Manufacturing Notice

Name:	Final Finish on Flip-Lid Ashtray Insert
-------	---

Affected Parts:	All Flip-Lid Ashtray Inserts (FLA).
Part Names:	Rim and Lid

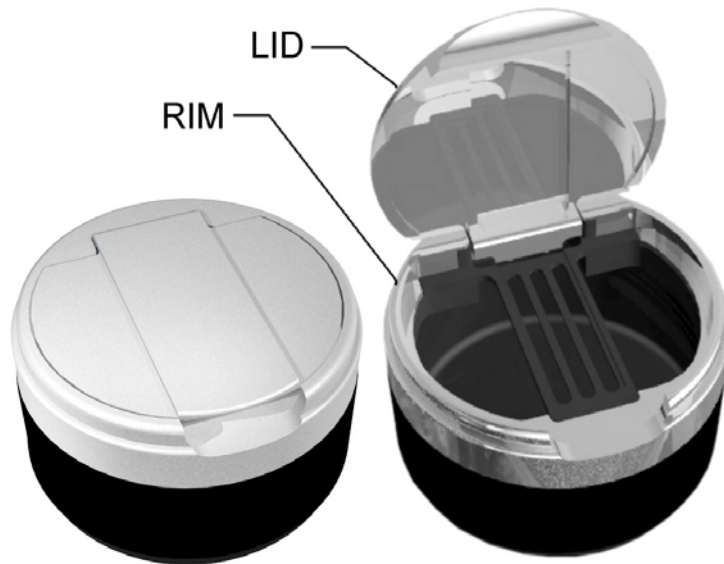
Aluminum parts for the Flip-Lid Ashtray have been precision machined to provide tolerances for normal plating thicknesses and possible clear coat finishes. Avoid heavy build-up or pooling of any final finish on surfaces and corners as this will prevent the ashtray from operating properly.

Name:	Final Finish on Flip-Lid Ashtray Insert Lid
-------	---

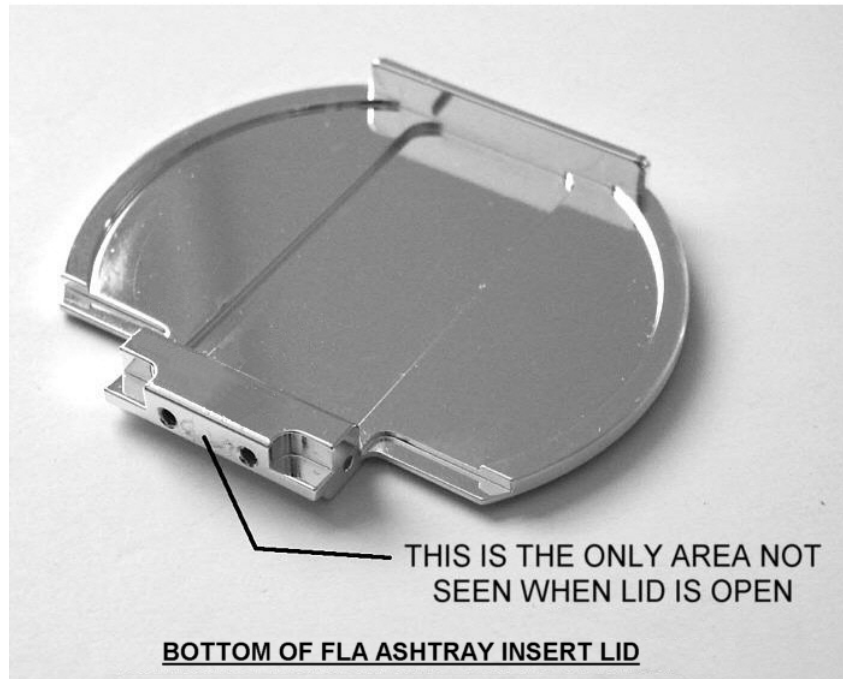
Except as indicated, all areas of the lid are visible during normal operation.
